INDEX

# 3/4.3 INSTRUMENTATION

RIVER BEND - UNIT 1

3/4 3-40

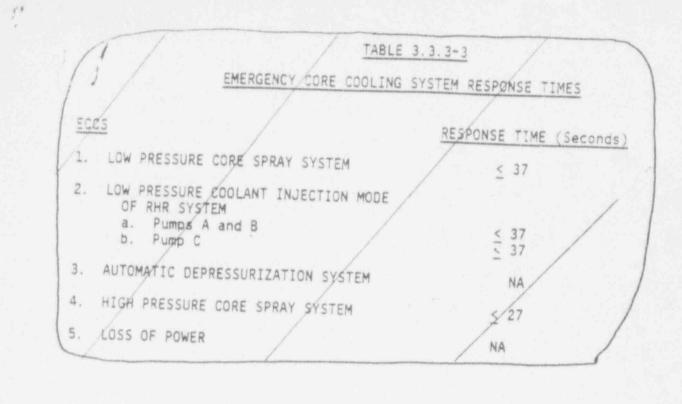
Table 3.3.3-3 has been deleted.
